**MARINE CORPS AIR STATION
EL TORO, CALIFORNIA - CTO 0145
RESPONSE TO COMMENTS REGARDING DRAFT FINAL
OU-1 INTERIM-ACTION FEASIBILITY STUDY REPORT
DATED 09 AUGUST 1996
CLE-C01-01F145-B7-0018
Revision 0**

**RESPONSE TO COMMENTS REGARDING
THE 09 AUGUST 1996 DRAFT FINAL OU-1
INTERIM-ACTION FEASIBILITY STUDY REPORT**

15 JANUARY 1998

**PREPARED BY:
BRAC OPERATIONS OFFICE
SOUTHWEST DIVISION NAVAL FACILITIES
ENGINEERING COMMAND**

Simulated TCE concentrations at North Lake well after 20 Years Alternative 7a

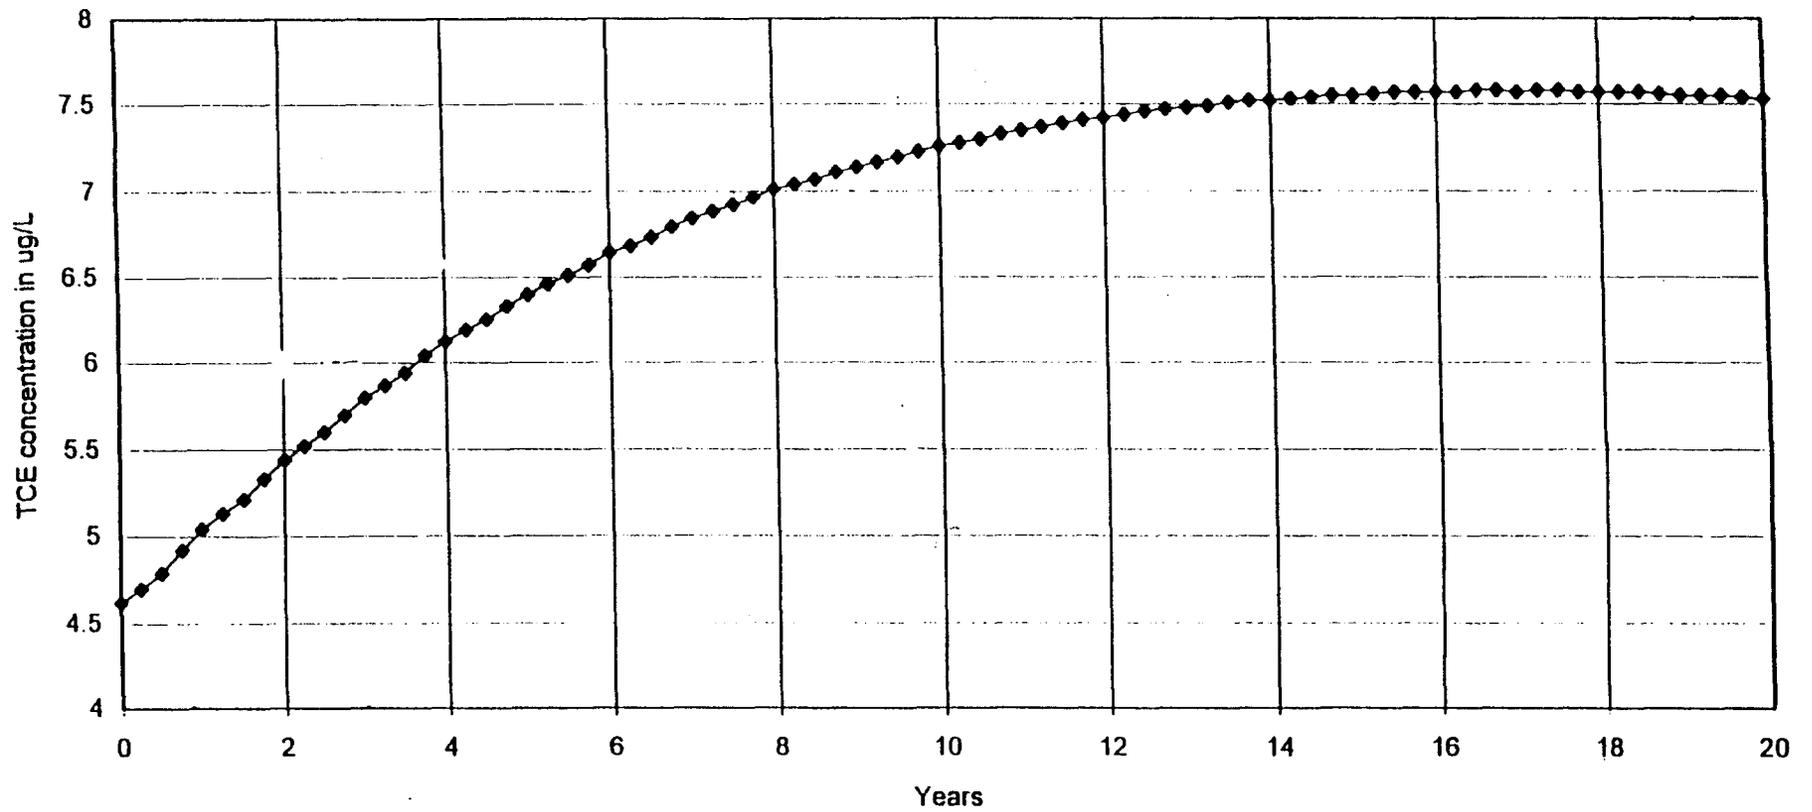
H. Levine stated that the analytical model presented in the model review report by Geoscience does not present a good match with the actual data at the North Lake Well (Figure 8 in the Geoscience report). He stated that he disagrees with the Geoscience modeling approach and believes the data should have been evaluated as a population rather than picking the worst-case scenario (highest concentrations). Because sampling data can be influenced by sampling and analysis variations, as well as heterogeneities, H. Levine believes a model should reflect the response of the entire population of data, not just the highest concentrations.
